1ST COA SUBMITTAL

56TH & PICADILLY MARKETPLACE
OFFSITE IMPROVEMENT SITE PLAN

SITE PLAN

LANDSCAPE
WATER USE
EXHIBIT &
DETAILS

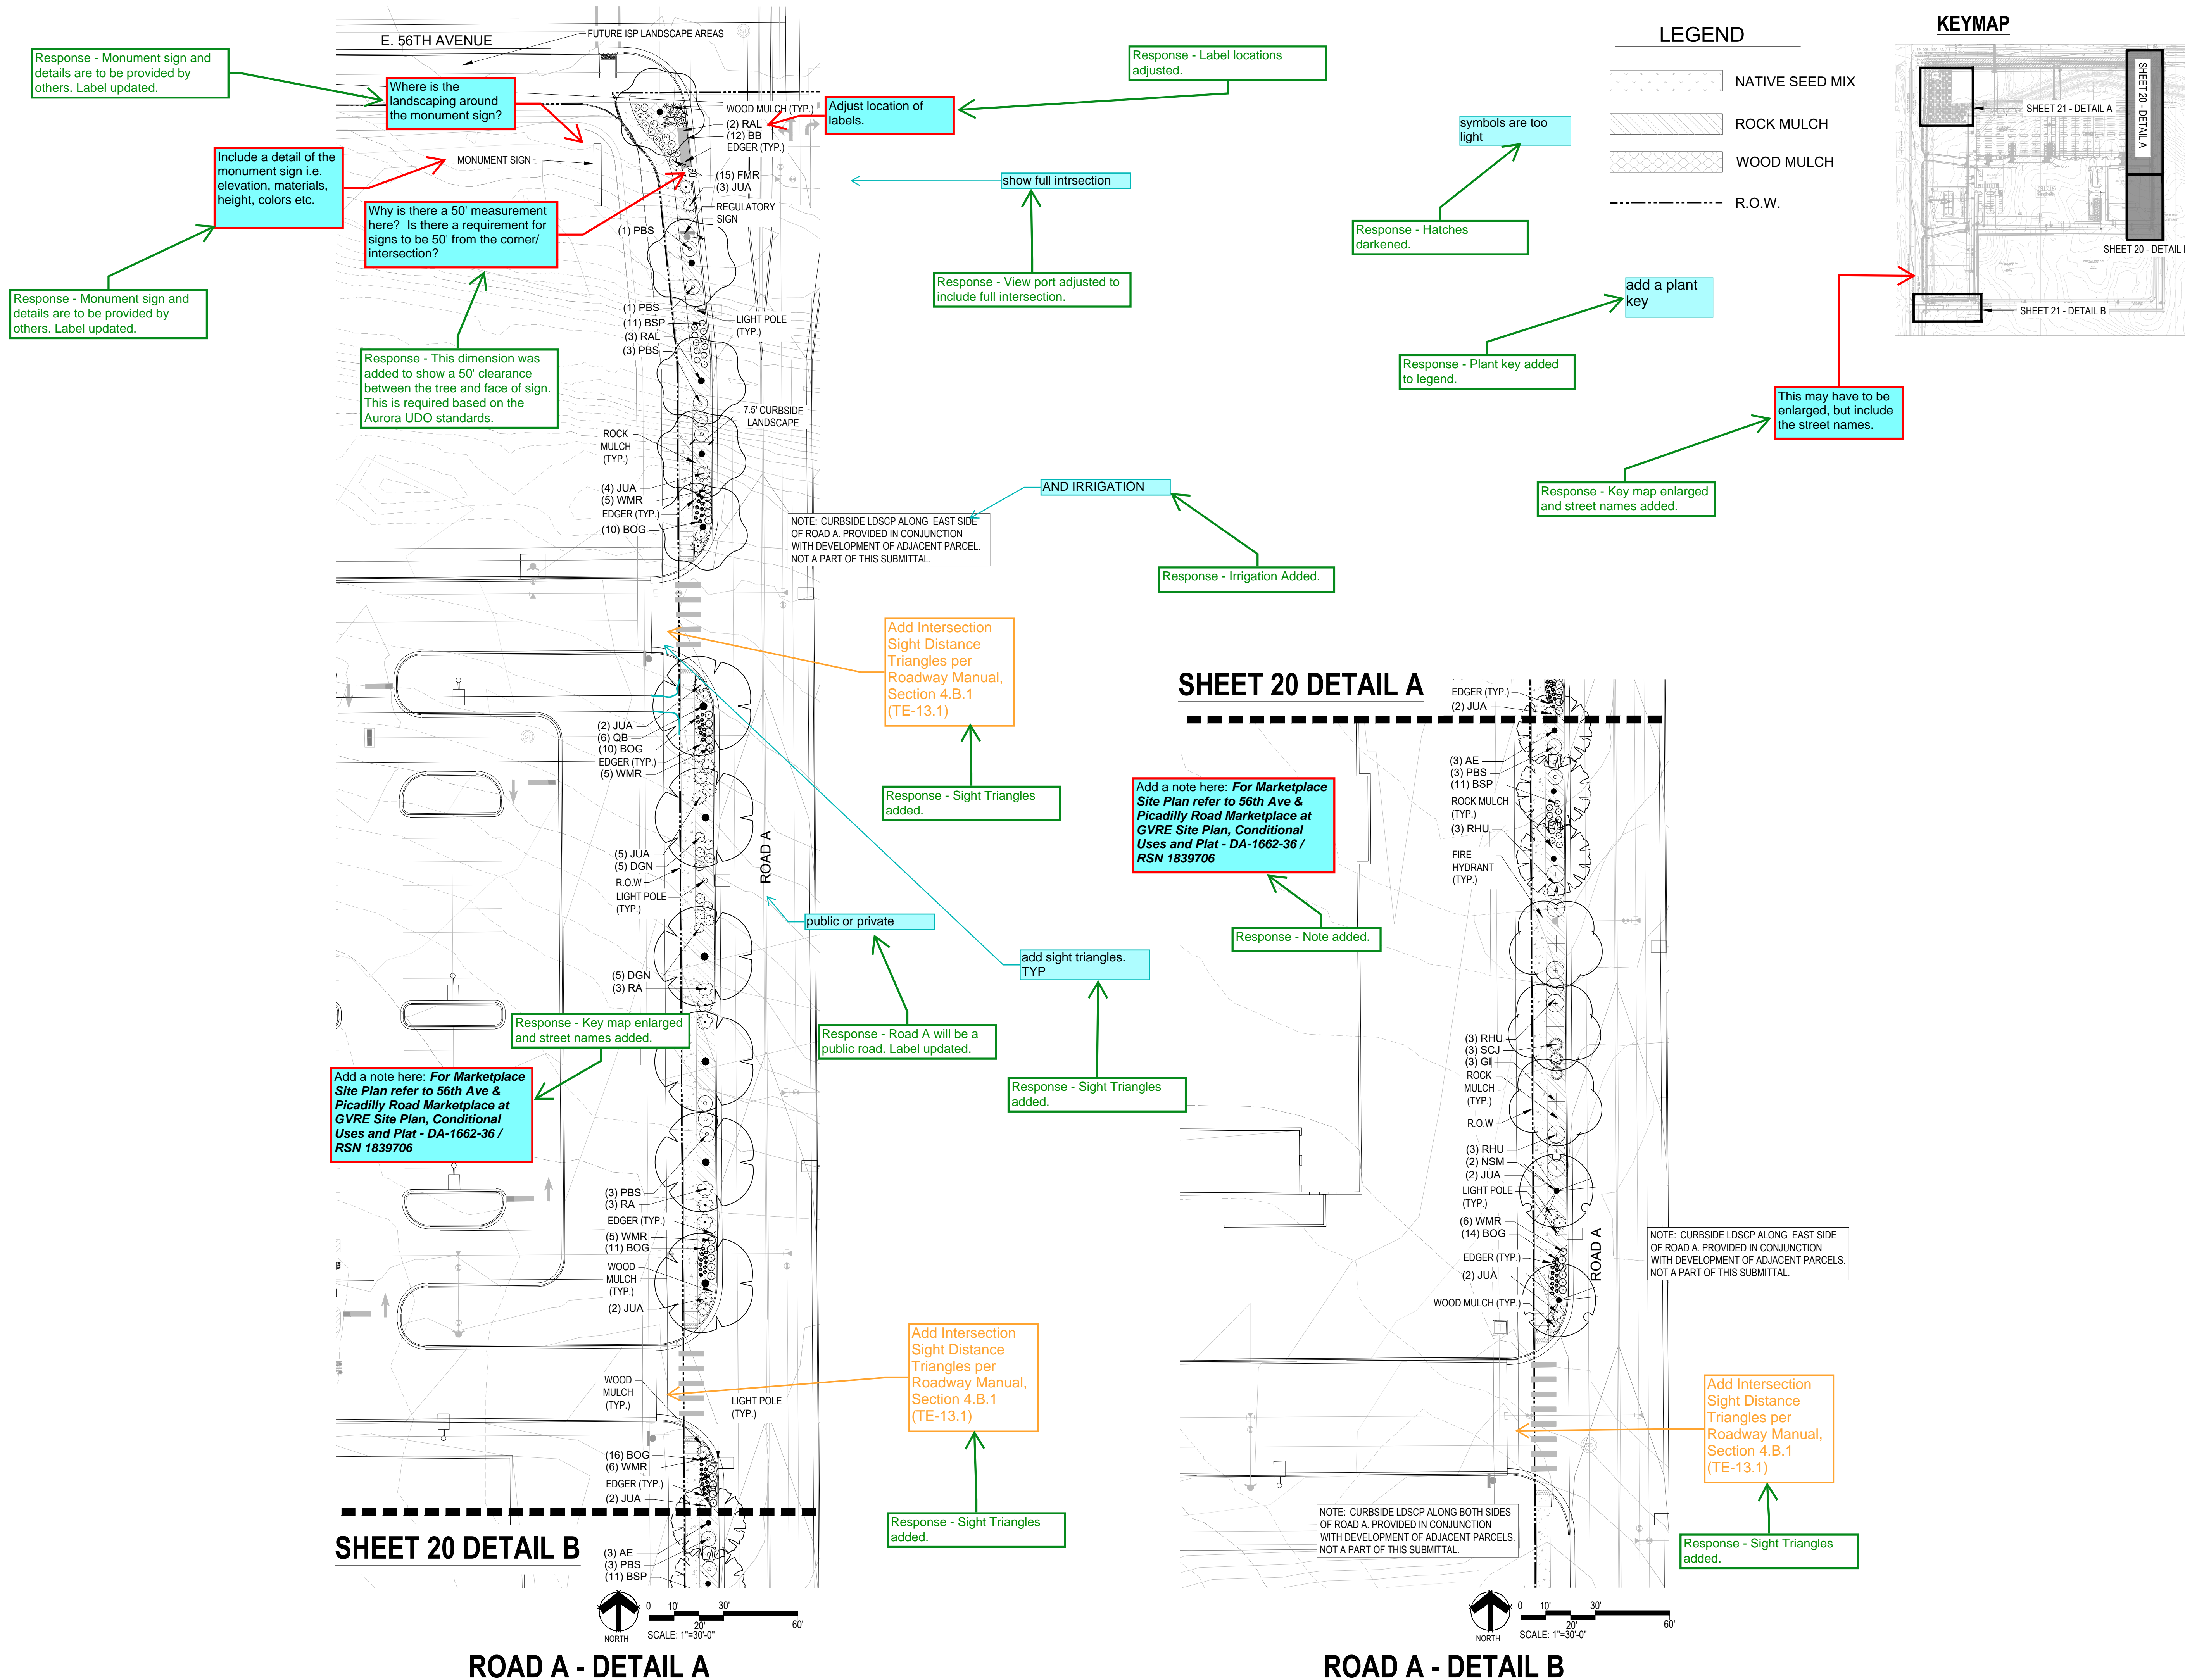
This should be the last landscape sheet. Please relocate this with the next submittal.

Response - Sheet relocated to last sheet.
